Reliability Analysis Update

Transmission Expansion Advisory Committee
August 5, 2025

2025 RTEP Window 1 Update

Baseline Reliability Projects Changes to Previously Approved Projects

Scope: Broadford 765 kV Upgrade: Replace Jackson's Ferry
CB Q2 (B4000.200)

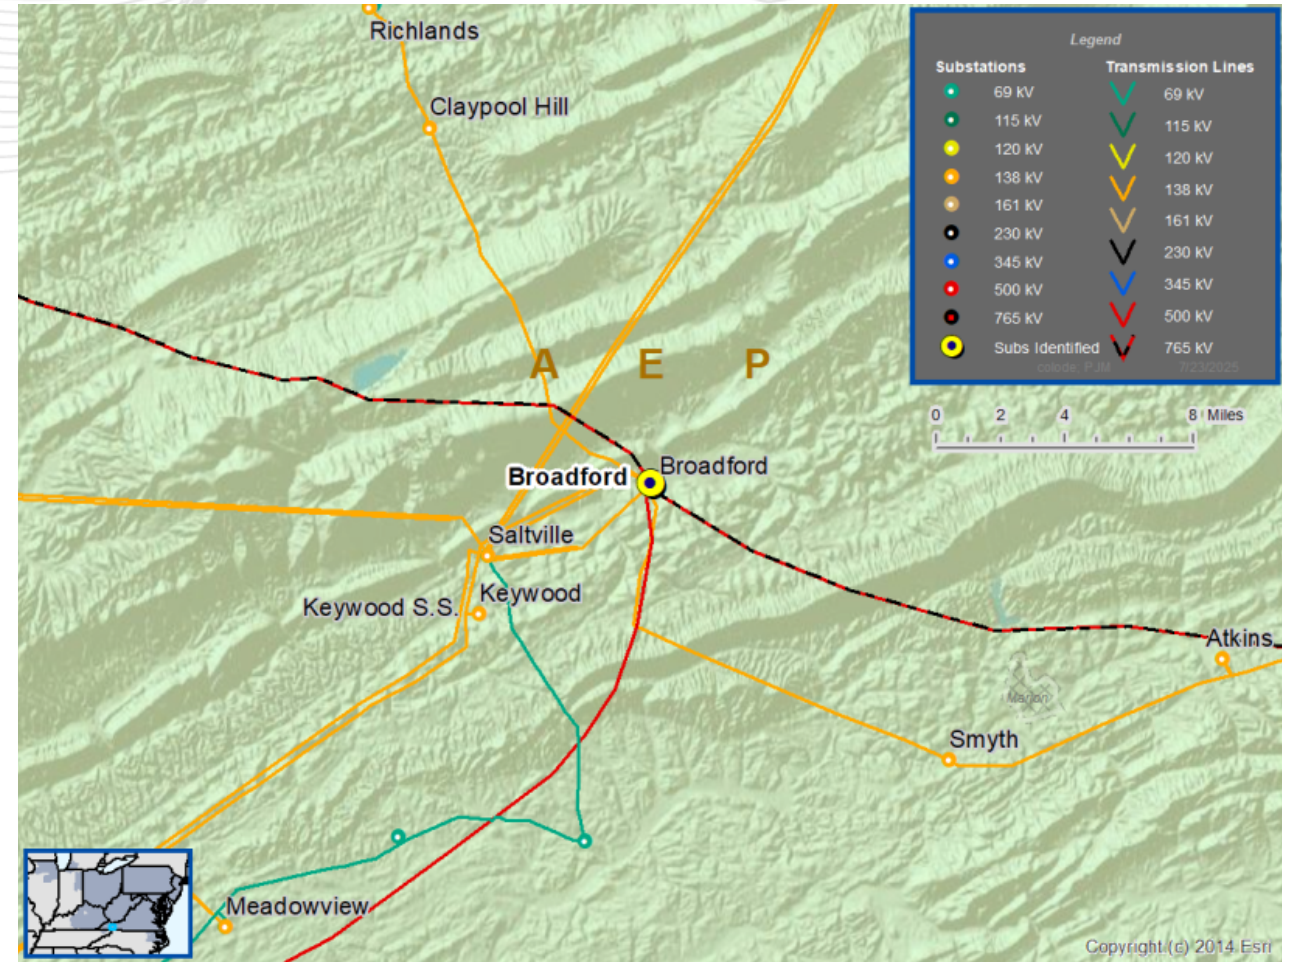
Reason for Cancellation: Rating error in the study for the
breaker. With corrected ratings, the project is not needed.
